Access Compliance Report

Public Rights-of-Way

(Curb Ramps)

Intersection ID: 45835	Main Street: CHRISTENBURY_HILLS_LN	Cross Street: KELDEN_WALKER_LN	Location: NE
ADA ID: 7326BB1FA1BD	Ramp Type: PerpDiag	Initial Pass/Fail: Fail	Overall Compliance: No
Severity Score: 55			
Codes/Mitigation Info/Possible Solution		Field Measurements/Component Compliance

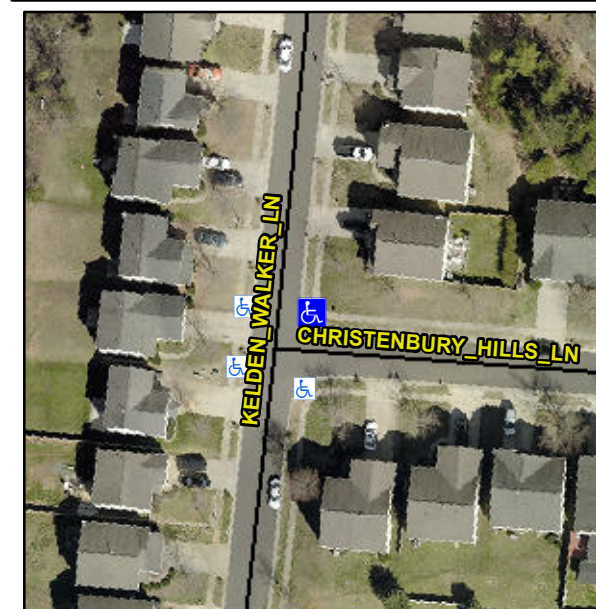
Not Found, R304.5.1, R304.2.2, R304.5.3

Compliance	Description	Data	Compliance	Description	Data
N/A	Ramp Length (in)	47.0	No	Ramp Slope (%)	10.5
No	Ramp Width (in)	33.0	No	Ramp XSlope (%)	8.8
N/A	Flare Type LT	N/A	N/A	Flare Type RT	N/A
N/A	Flare Slope LT (%)	N/A	N/A	Flare Slope RT (%)	N/A
N/A	Flare Traversable LT?	N/A	N/A	Flare Traversable RT?	N/A
N/A	Landing Length (in)	N/A	N/A	DWS Provided?	N/A
N/A	Landing Width (in)	N/A	N/A	DWS Contrast?	N/A
N/A	Landing Slope (%)	N/A	N/A	DWS Length (in)	N/A
N/A	Landing X Slope (%)	N/A	N/A	DWS Full Width?	N/A
N/A	Landing Curb? (Y/N)	N/A	N/A	DWS Offset (in)	N/A
N/A	Shared Landing?	N/A			
N/A	Gutter Ponding?	N/A	N/A	Gutter Slope (%)	N/A
N/A	Gutter Lip Ht (in)	N/A	N/A	Gutter X Slope (%)	N/A
N/A	Painted X Walk1?	No	N/A	Painted X Walk2?	No
	X Walk 1 Direction	To W		X Walk 2 Direction	To S
N/A	X Walk 1 Width (in)	N/A	N/A	X Walk 2 Width (in)	N/A
	X Walk 1 Slope (%)	1.0		X Walk 2 Slope (%)	5.0
	X Walk 1 X Slope (%)	8.9		X Walk 2 X Slope (%)	0.8

Remove & Replace Curb Ramp With Two New Directional Ramps or Equivalent.
